Product Change Notification / ALAN-05LSYV366

CCB 6137 Initial Notice: Qualification of MMT as an additional assembly site for selected MCP4232xx, MCP4242xx, MCP4262xx, MCP4252xx, MCP4632xx, MCP4642xx, MCP4652xx, MCP4662xx, MCP7383xx, MCP3423xx, and MCP3427xx device families available in 10L DFN (3x3x0.9mm) package.

PCN# ALAN-05LSYV366

Pre and Post Change Summary

NSEB

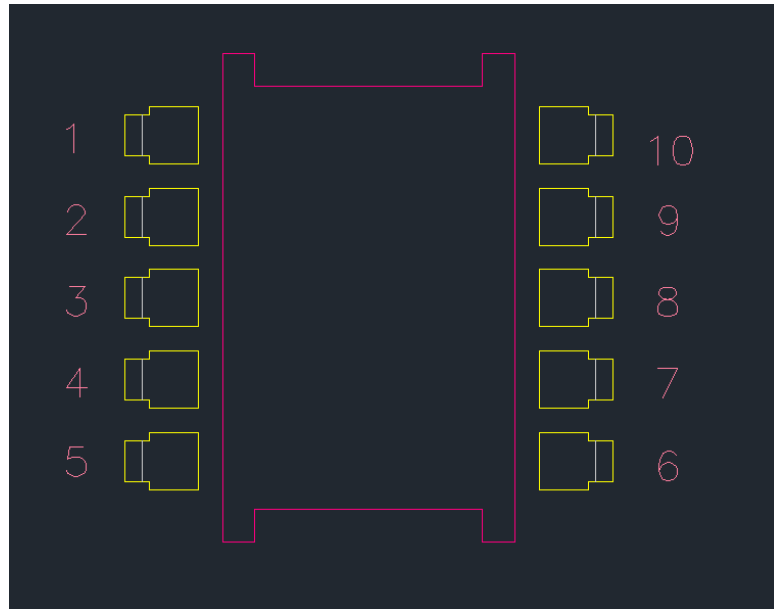
Lead Frame Material	C194
DAP Surface Prep	Bare Cu
Lead-Lock	No

MMT

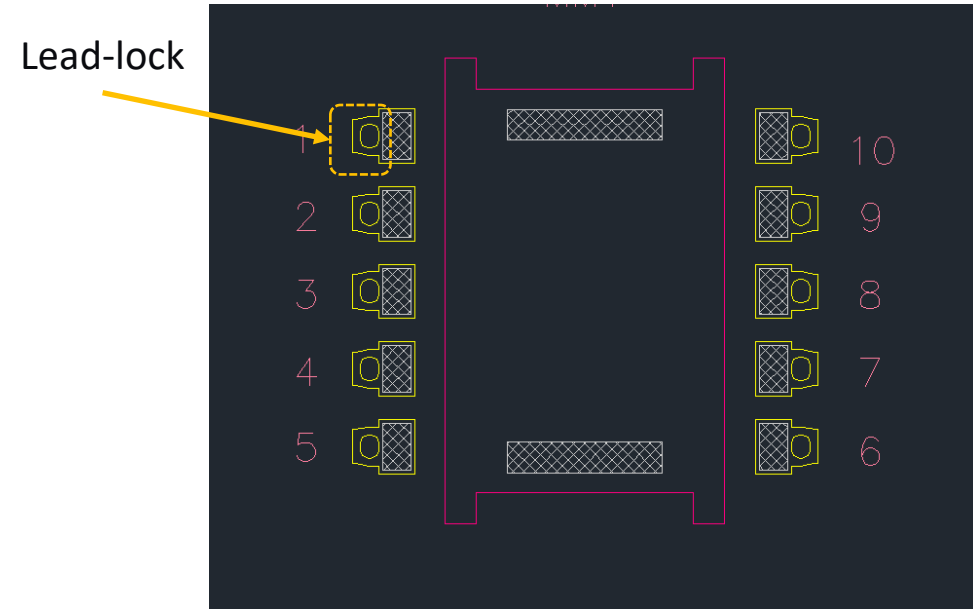
Lead Frame Material	A194
DAP Surface Prep	AG selective
Lead-Lock	Yes
